ACCESS
MAIN DECK
COMPARTMENT & ACCESS

BUREAU OF SHIPS PLAN NUMBER
AGC7-S1601-489192 ALT. 4

ACCESS
2ND DECK
COMP. & ACCESS

TITLE
ACCESS
2ND PLATFORM
COMPARTMENT & ACCESS

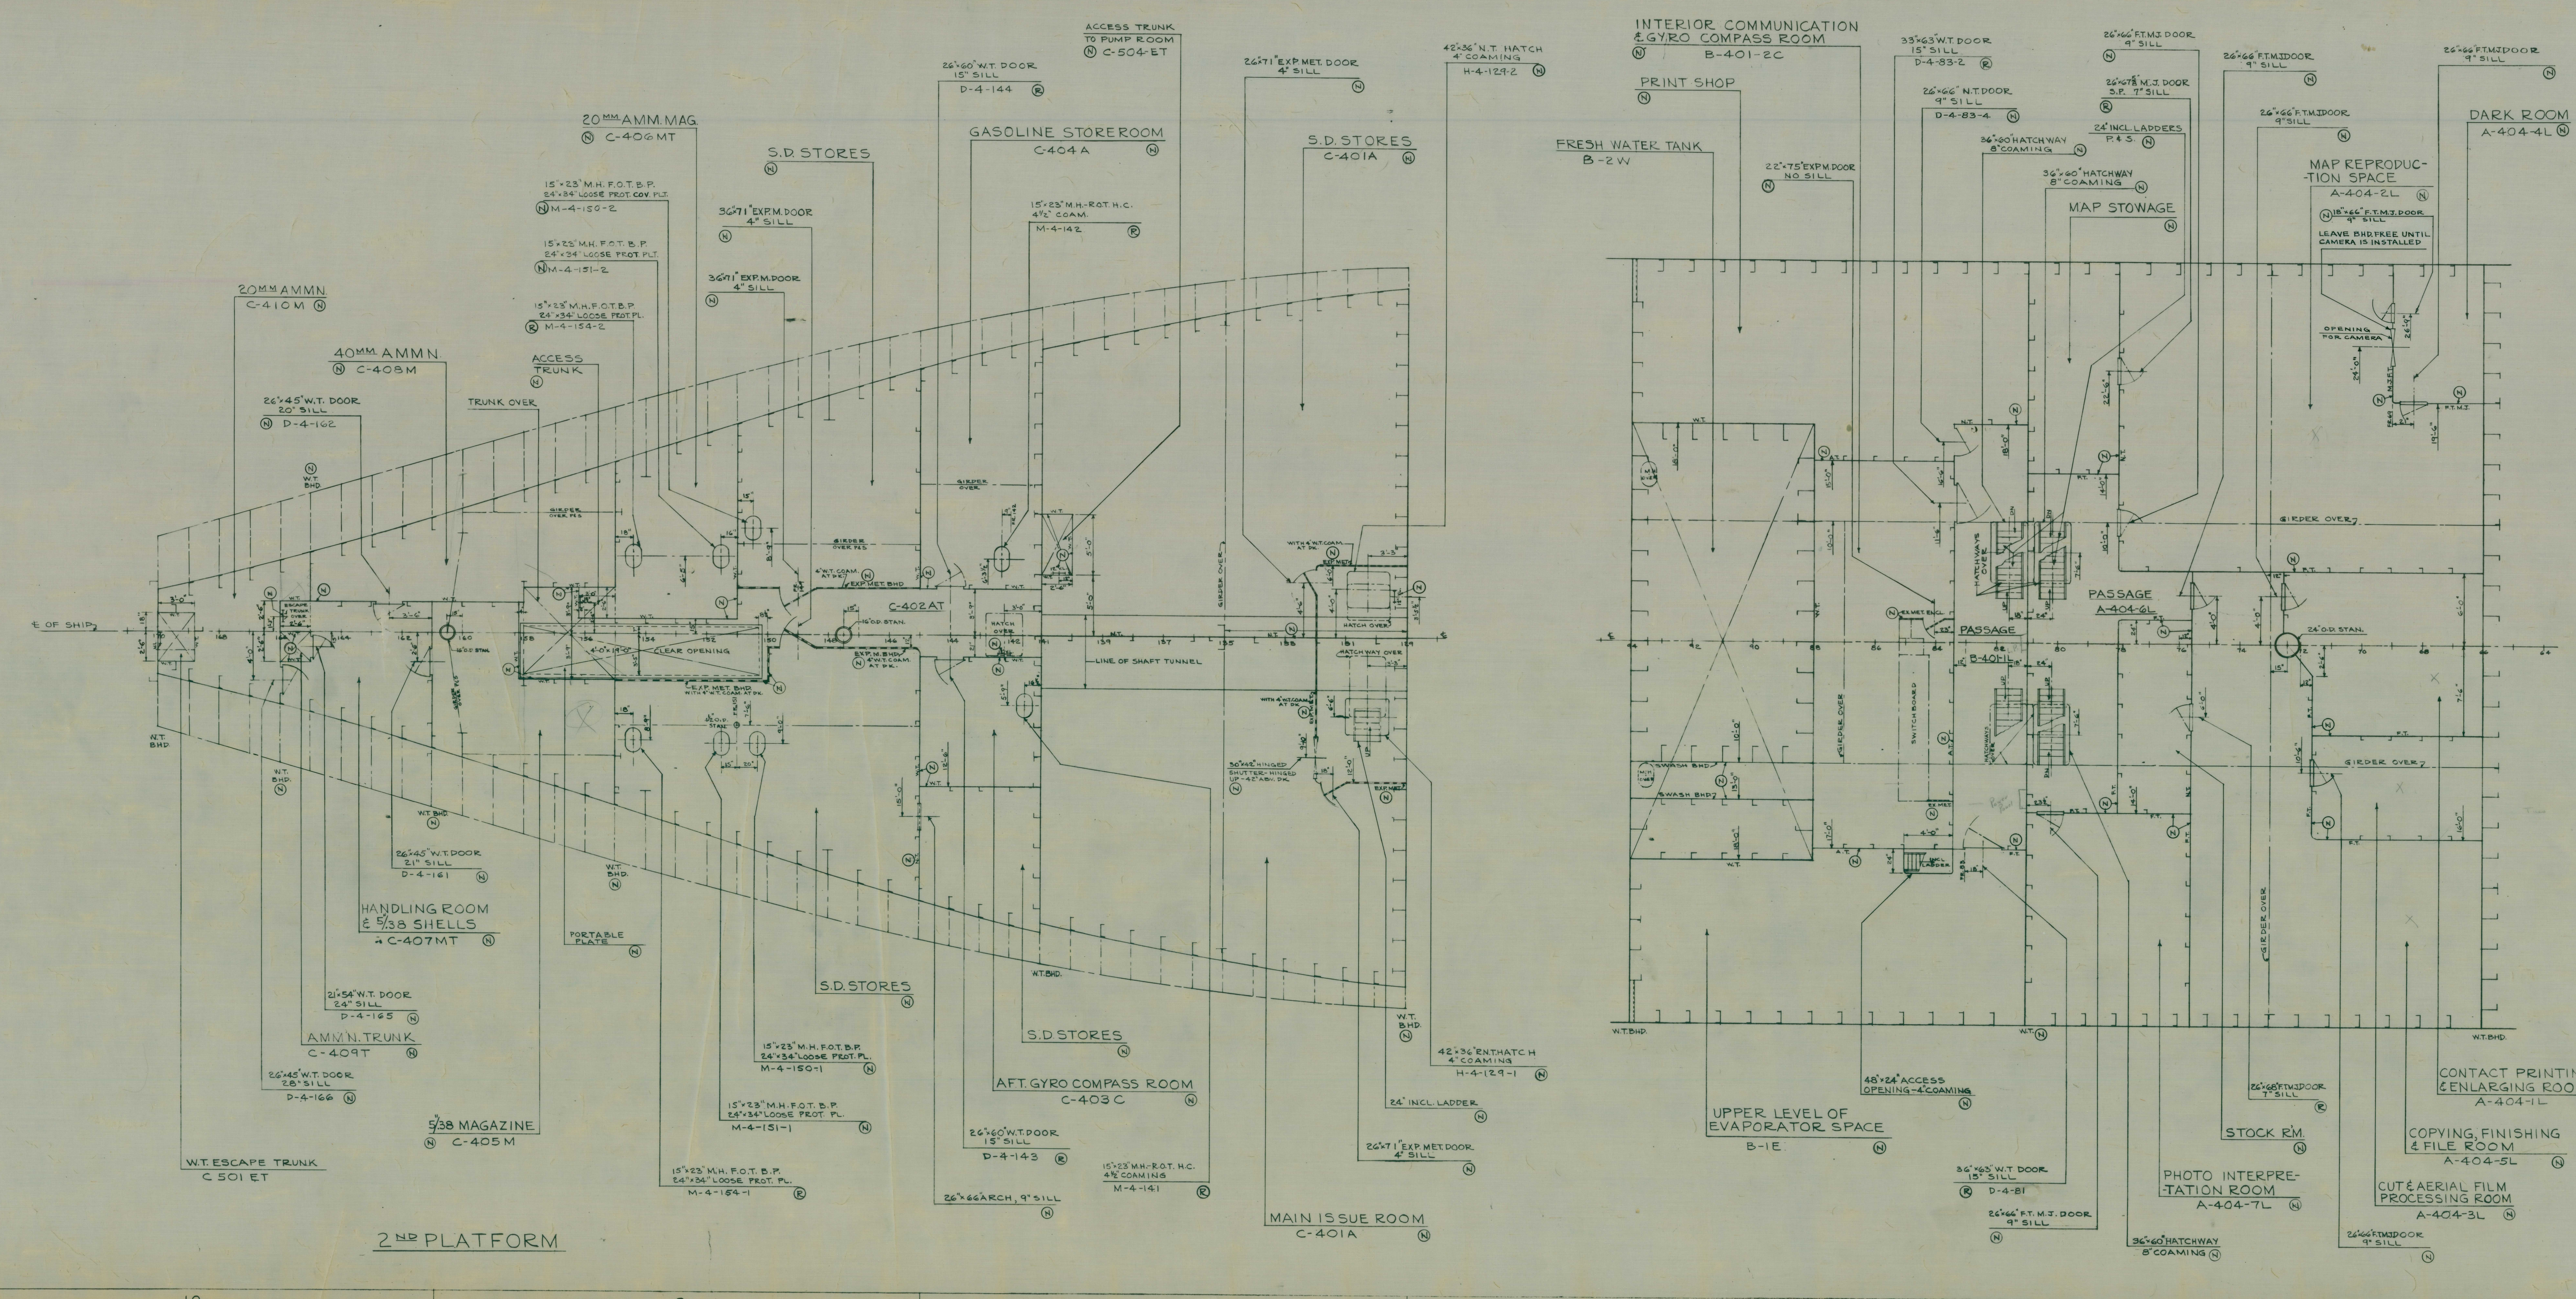
No	PANEL No	DESCRIPTION	APPROVED	DATE	B/M AFFEC'D
2.	3.	℄ LONG. M.J. BHD. & LONG. M.J. BHD 12'-6" OFF ℄ FR. 38-41. CHANGED TO N.T. TRANS. M.J. BHD. FR 38 S CHANGED TO N.T.	wwk	2/15/44	
	3.	26"x68" F.B.M.J. DOOR 18" AFT. FR. 38 S 12'-6" OFF ℄ RELOCATED TO 10'-0" OFF ℄ S.			
	3	26"x66 1/2" S.P.M.J. DOOR 8'-6" OFF ℄ S FR 38 ADDED.			
3	8.	KINGPOSTS FR 141-12'-6" OFF ℄ P/S MODIFIED.	FWJ	3/11/44	
	9.	LONG'T N.T. BHD. FR 165 P. MODIFIED. & TRANS N.T. BHD. FR 165-166 1/4" 16'-7" OFF ℄ ADDED.			
	7.	EXP. M. BHDS. FOR ICE CREAM MACH. RM. FR. 129-TO 18 1/2" AFT. FR. 132-P. MODIFIED.			
	4.	CHAPLAIN'S OFFICE FR 51-54-P 3'-9" OFF ℄ ADDED TO PLAN.			
	3.	TRANS. N.T. BHD. FR 30 FROM ℄ TO 10'-0" OFF ℄ P/S CHANGED TO F.T.			
	5	M.J. DOOR 12" FWD. FR. 69 INTERCHANGED WITH M.J. DOOR 12" AFT. FR 78-20'-0" OFF ℄. PORT ONLY.			
4	6	H-2-100 ADDED TO PLAN & TRUNK UNDER INDICATED.	FWJ	4/20/44

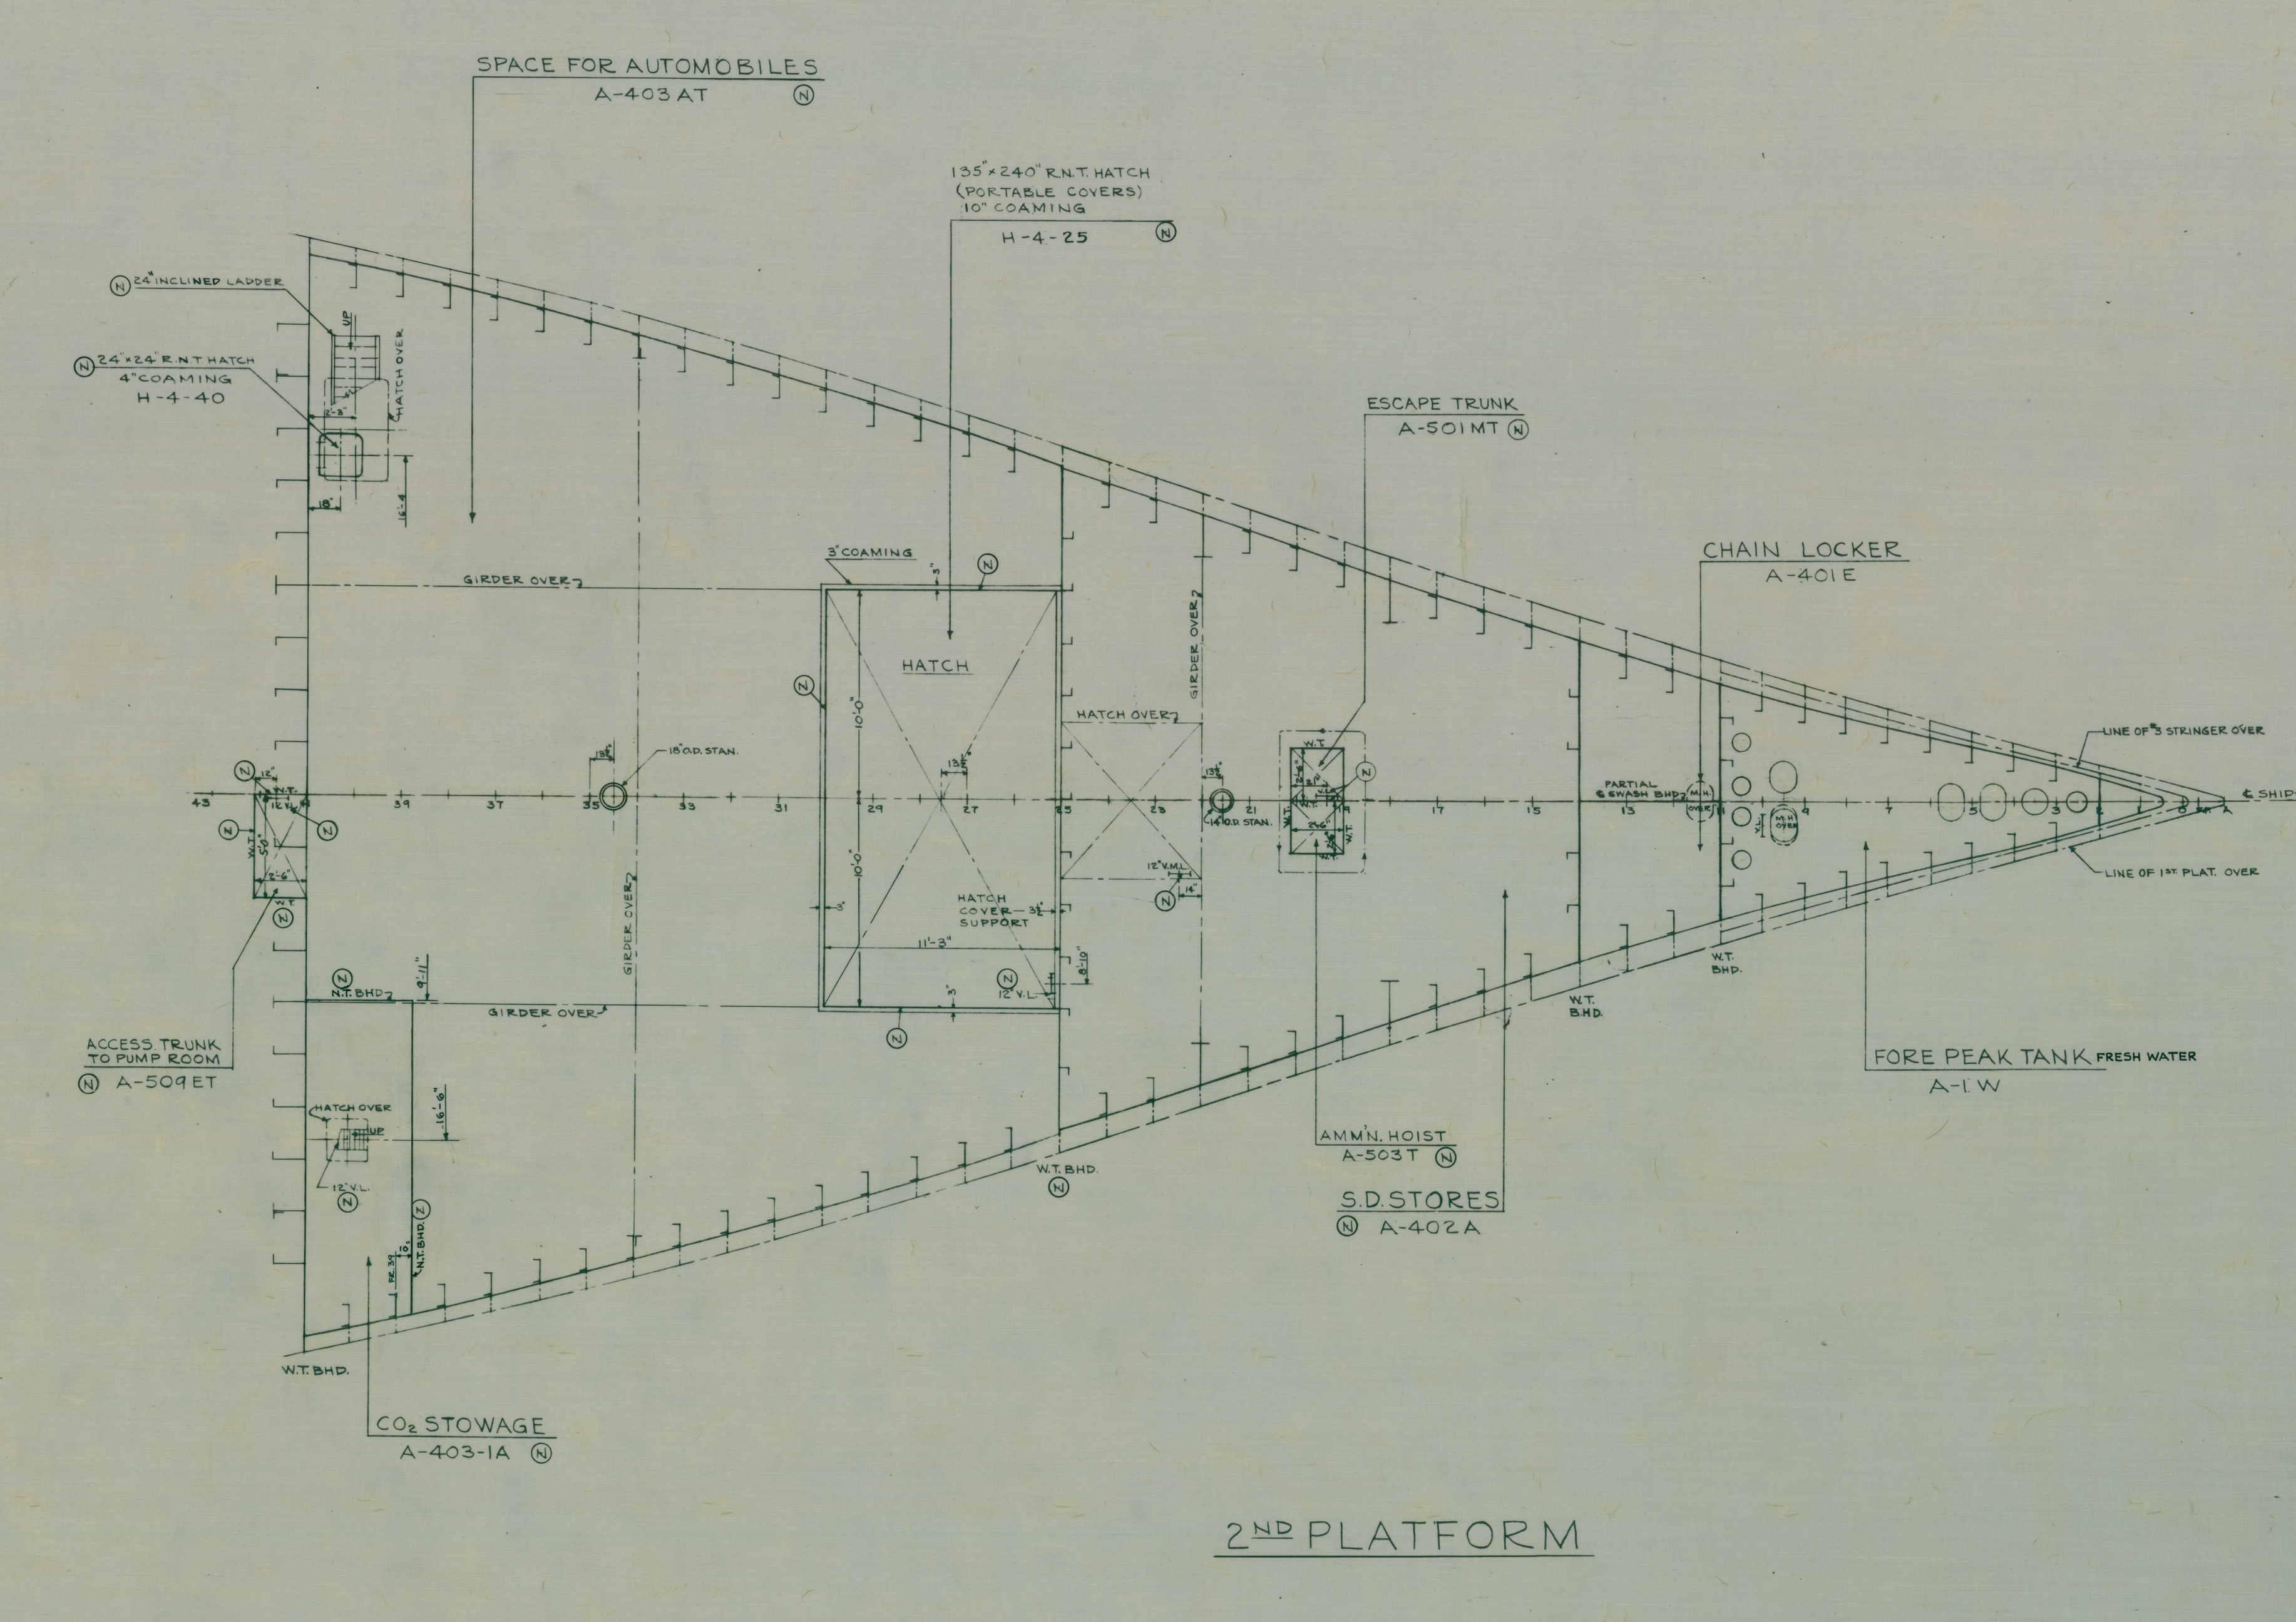
NO.	PANEL NO.	DESCRIPTION	APPROVED	DATE	B/M AFFEC'D.
1	8,9,10 3,5,7, 8,9,10,	4" W.T. COAMING INSTALLED UNDER EXP. MET. BHDS. ENCLOSING MAIN ISSUE RM. & S.D. STORES FRS. 129-132 P&S. AND S.D. STORES, FRS. 145-155 P&S. EXP. MET. DOORS CHANGED TO SUIT. ALL M.H. OVER ADDED. GIRDERS OVER BETWEEN FRS. 129-170 ADDED. MANHOLE (M-4-141) RELOCATED G.W.W.	HG	1/13/44	
2	5	NEW DOOR ADDED ON FR 69, 26'-9" OFF ℄ PORT. CENTERLINE OF OPENING FOR CAMERA RELOCATED TO 24'-0" OFF ℄ PORT ON BHD. 69. DOOR LOCATED AT 21" FWD. OF FR. 69 & 19'-6" OFF ℄ PORT CHANGED IN SWING FROM OUTB'D. & AFT. TO INB'D. AND FWD. H.F.U.	FWJ	3/16/44	
3	4	BHD. ON FR. 39 STBD. RELOCATED TO 10" FWD. OF FR. 39. BHD. 9'-11" STBD OFF ℄ BETWEEN FRS. 39-41 & BHD. 10" FWD OF FR. 39 S CHANGED FROM F.T.M.J TO N.T. BHD.	FWJ	4/15/44
